THREE MILE ISLAND NUCLEAR STATION UNIT 1

Operating License No. DPR-50
Docket No. 50-289
Technical Specification Change Request No. 31

Technical Specification Change Request No. 31

FIGURE 2.3-1

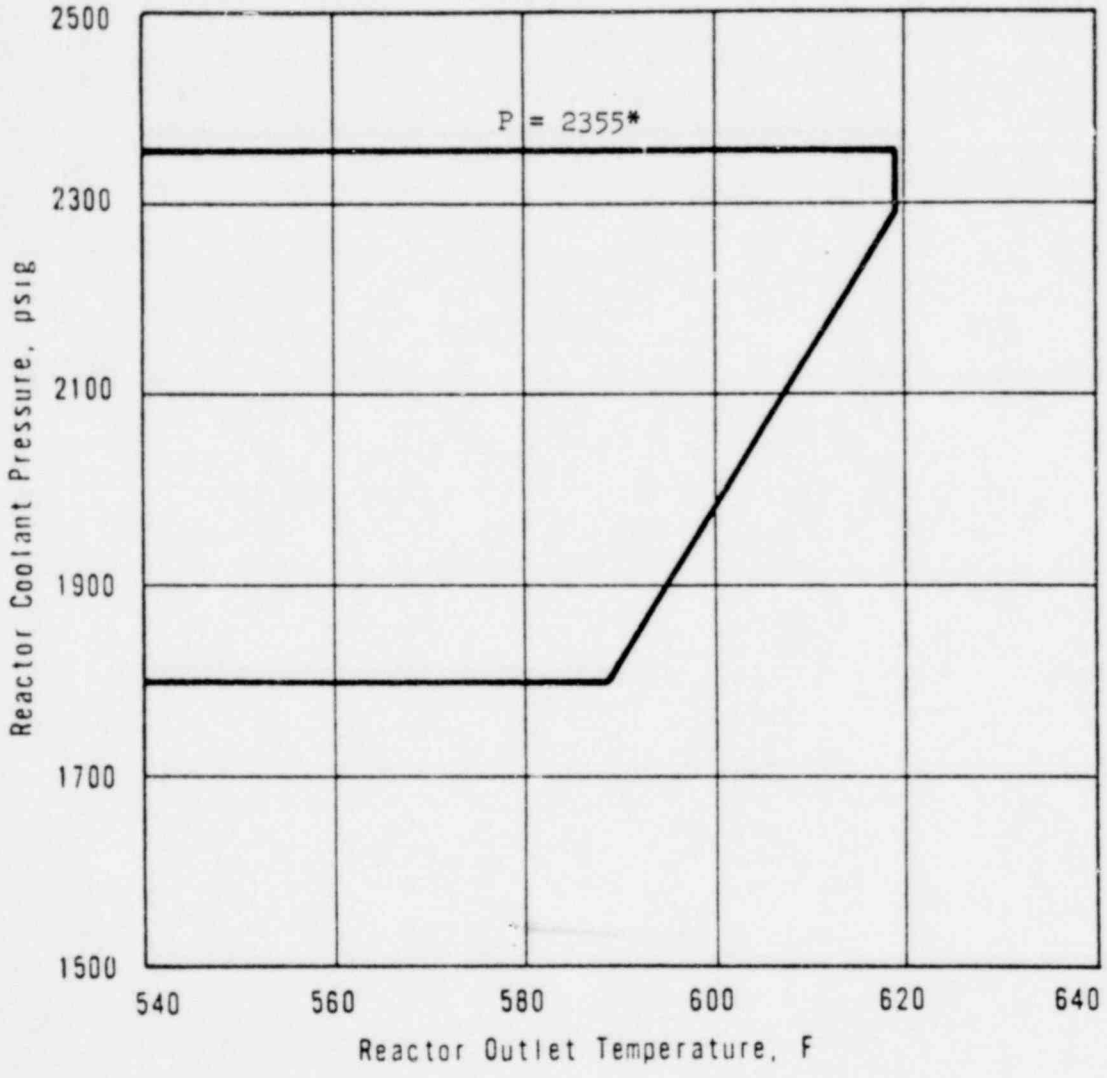
During a startup accident from low power or a slow rod withdrawal from high power, the system high pressure trip set point is reached before the nuclear overpower trip set point. The trip setting limit shown in Figure 2.3-1 for high reactor coolant system pressure (2355*psig) has been established to maintain the system pressure below the safety limit (2750 psig) for any design transient.

* Except as specified in 2.3.2

2.3.2 For the 24 hour period prior to shutdown for refueling the high pressure trip setpoint may be increased to 2405 psig provided that the following precautions are taken during this period.

a. If pressurizer level exceeds 315 inches as indicated by the high-high level alarm, the reactor shall be manually tripped.

b. If the reactor drain tank pressure exceeds 15 psig, the reactor shall be manually tripped.
